Fabco Valve Upgrade

Model 500 4-way Solenoid Valve

Quality Issues & New Applications Drive Supplier Change

Figure 1: S-N Curve for Aluminum & Titanium Alloy

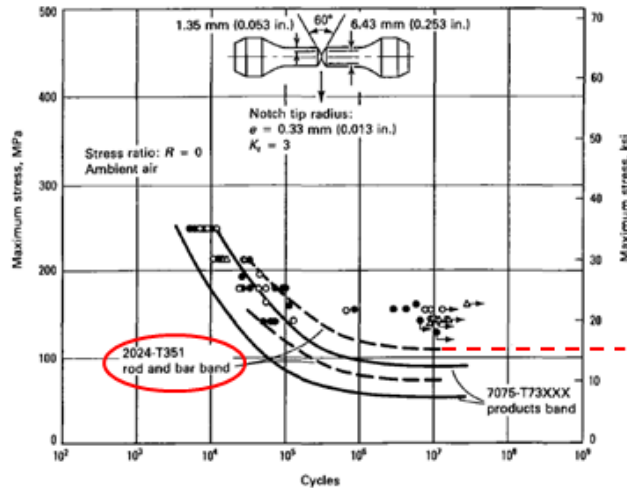
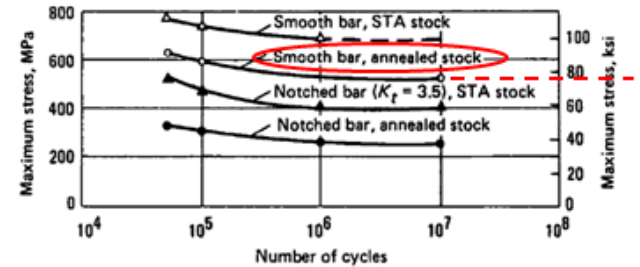
Figure 1 shown Titanium alloy material has superior endurance limit five times higher than Aluminium alloy.

Aluminum → Endurance limit, 15 Ksi

Titanium → Endurance limit, 75 Ksi

Figure 2 : Spool actual failure photograph, failed @ middle groove

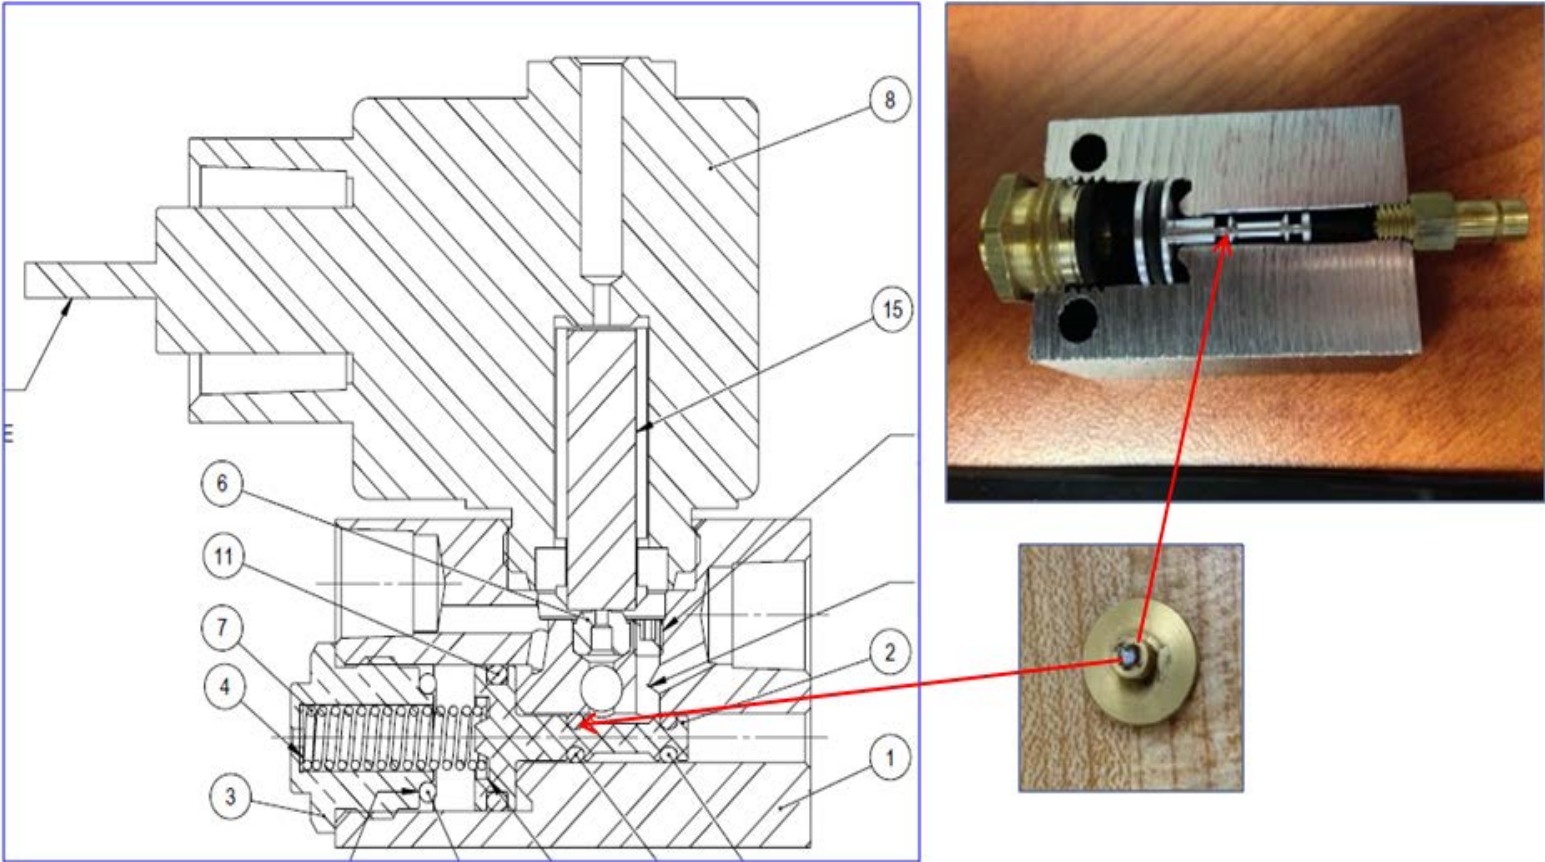
- **March 2014**: Engineering and Quality visit Fabco to investigate root cause of broken spool. The test result shown Titanium spool has superior endurance limit five times higher than the current Aluminum spool. Titanium spool is the recommended permanent and long term solution for the broken spool.

- **June 2014**: Fabco implemented the Titanium spool in production
- **August 2014**: Received the first shipment of valve with Titanium spool
- **October 2014**: First shipment of the Model 500 GC with the Titanium spool solenoid valve
